Our Ref: TR/11577

10 February, 2021

RE: DEE WHY 7-ELEVEN PETROL STATION RESPONSE TO MATTERS RAISED BY TINSW

AMENDED SITE PLAN

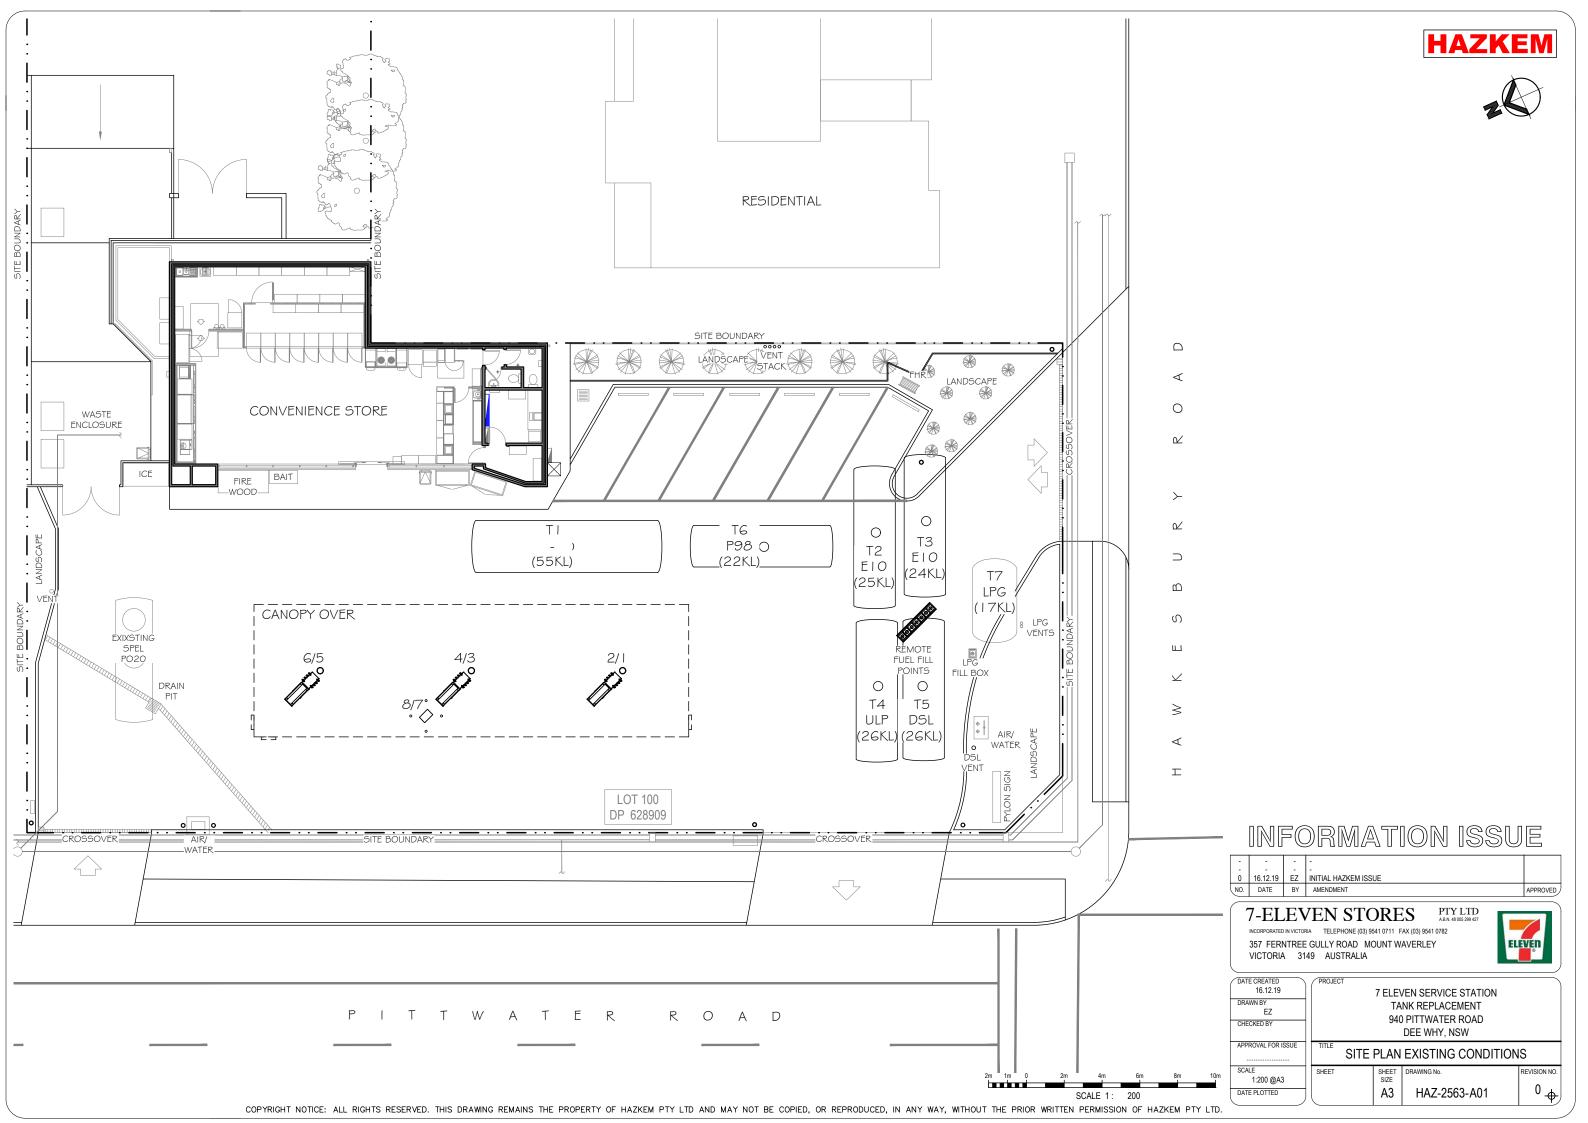
- i. The submitted plans indicate that the tanker will be blocking two traffic lanes on Pittwater Road within close proximity to the signalized intersection, whenever they are required to wait for vehicles to exit at the proposed entry/exit driveway on Pittwater Road. It is requested that this driveway is changed to 'entry only' to address this concern. All vehicles should exit onto Hawkesbury Road

- ii. Another option might be for the proponent to consider widening the first entry driveway on Pittwater Road for the tankers. However, this depends on whether the swept path analysis demonstrates that tankers can enter on Pittwater Road and exit on Hawkesbury Road in a forward direction

- the northern driveway will be widened (as suggested in the second point of the TfNSW letter). The required widening is shown on the plan provided in Attachment A; and
